Department of Property & Procurement

AMENDMENT #2- IFB061DPWT20 (C)– Qualified contractors to furnish all labor, tools, equipment, and supplies necessary for the **Bolongo Bay Drainage- Phase I Project on St. Thomas, Virgin Islands**

7 BIO-RETENTION BASIN

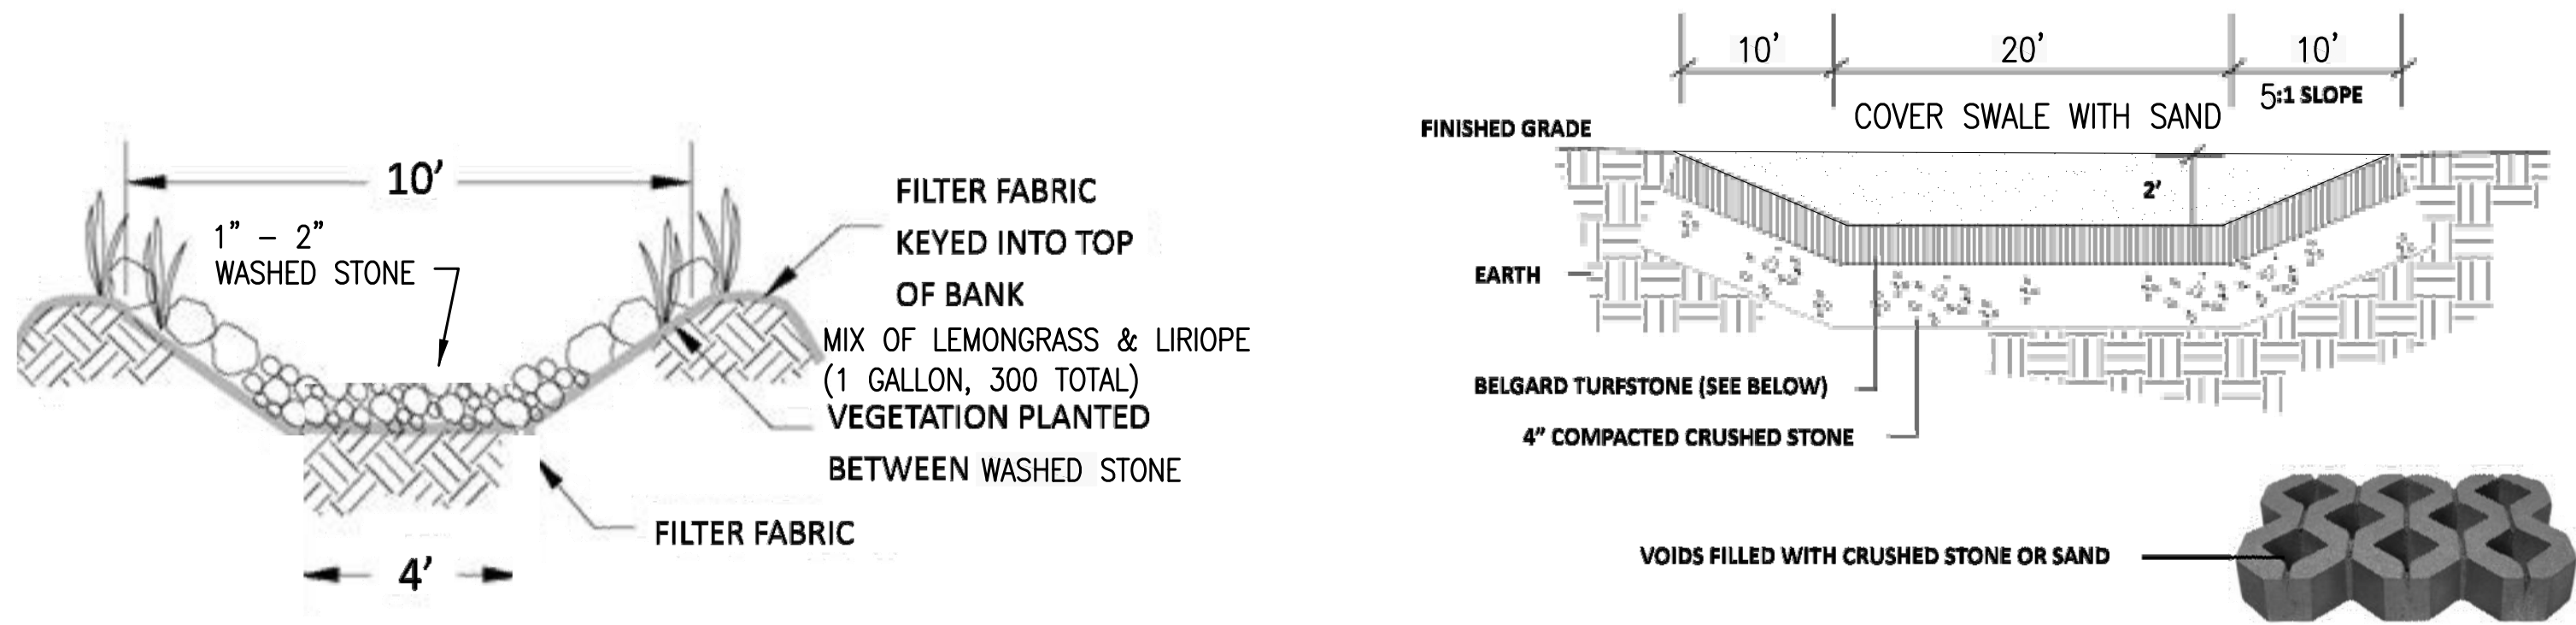
14. I cannot find a specification for the “Bioretention Soil” required for the construction of the Bio-Retention Basin. Can you please provide the spec so we can price the material necessary? [The Bioretention soil is a blend of 80% washed coarse Sand and 20% sandy](#)

15. Also, can you please confirm the plantings within the basin are to be provided by the contractor. Yes, the plantings within the basin shall be provided by the Contractor.

loam Topsoil.

3 CONCRETE SWALE @ ESTATE ROAD AND FOREBAY – PLAN VIEW

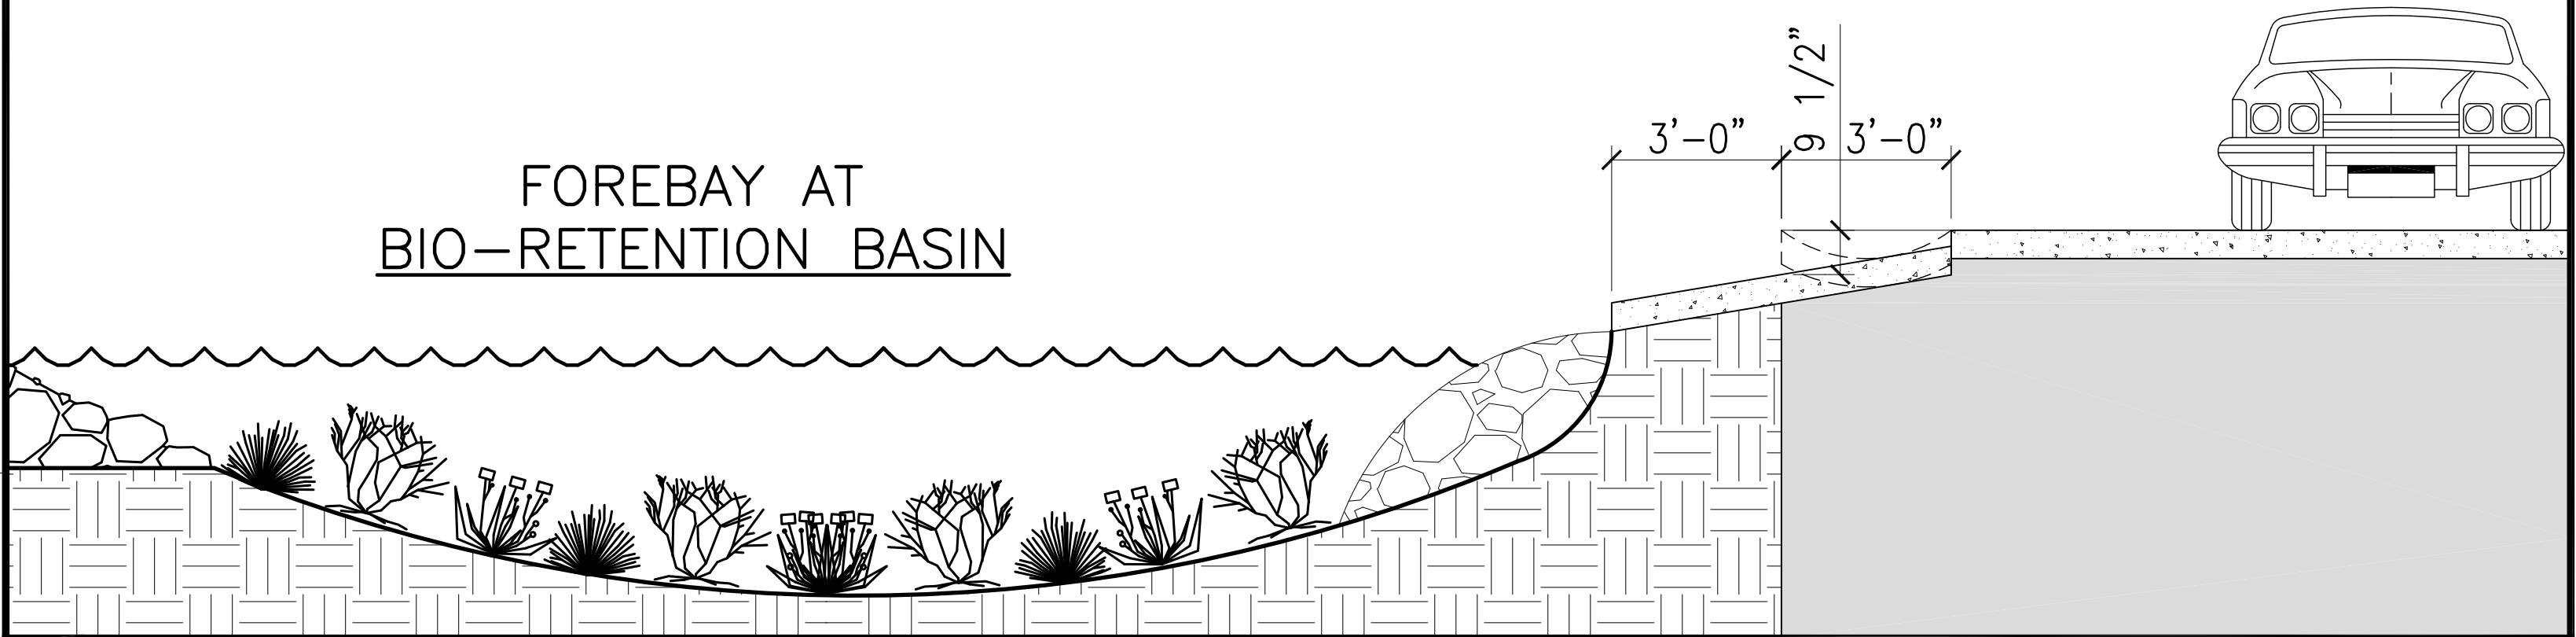
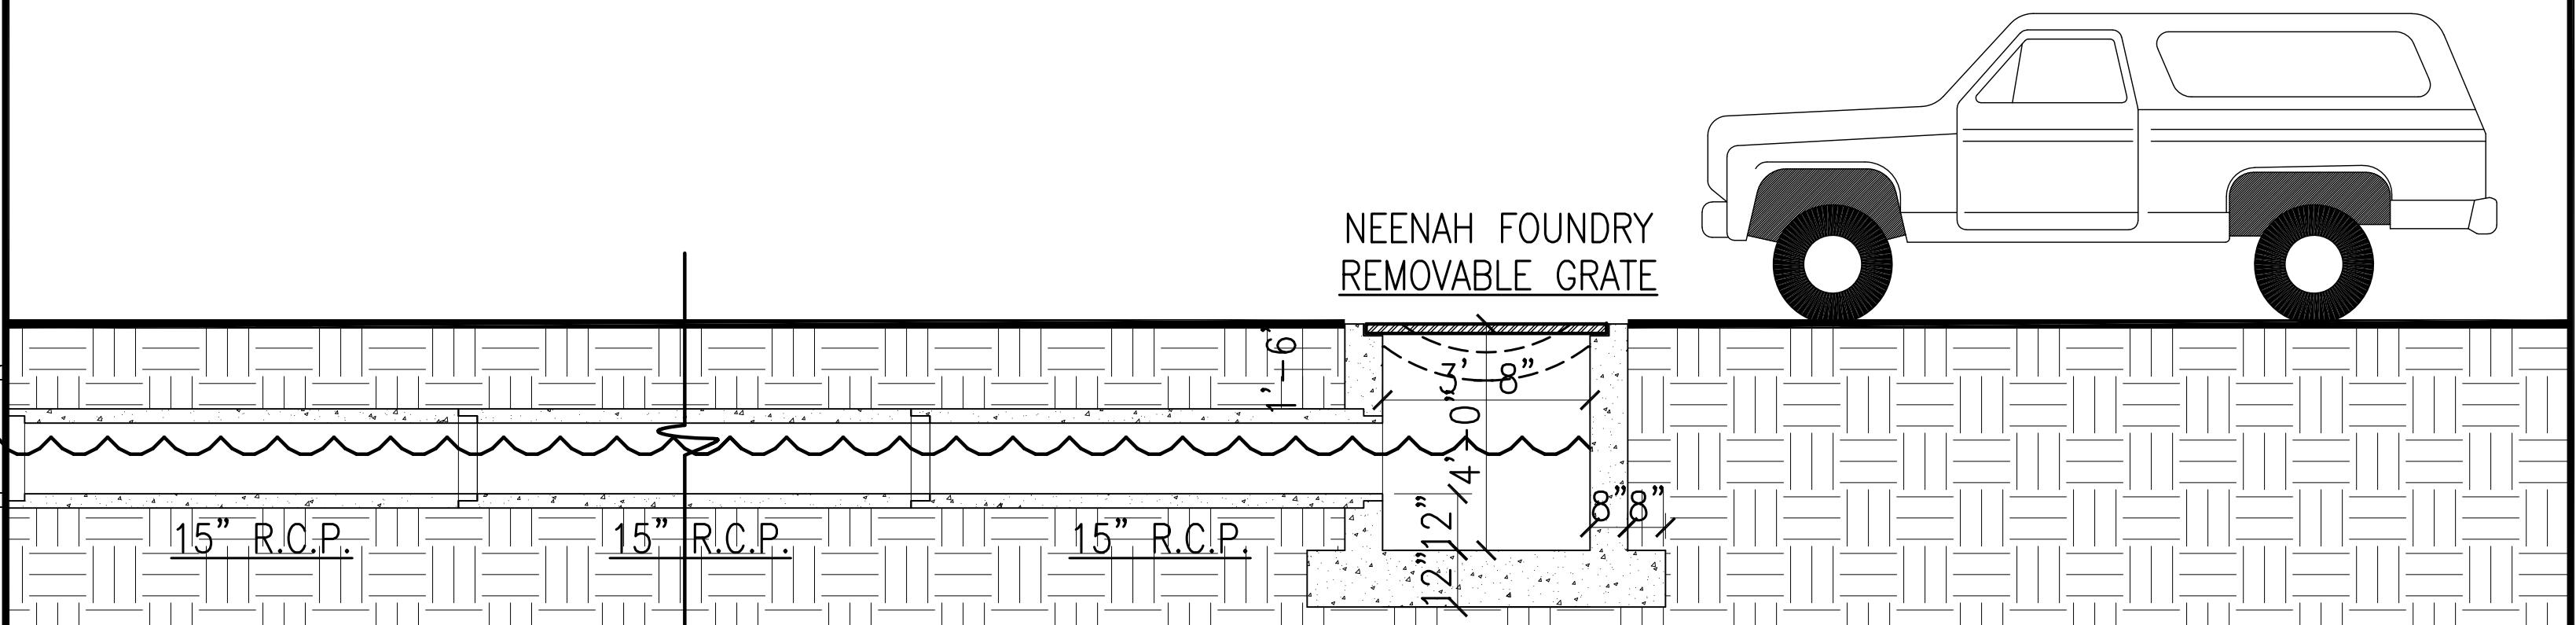
4. The Forebay appears to be in the wrong location. Should it be up near catch basin B? [Yes. See the Updated Plan.](#)
5. Is the top of the embankment at elevation 8.00 and not 8' high? [Yes. The top of the embankment is at elevation 8.00.](#)
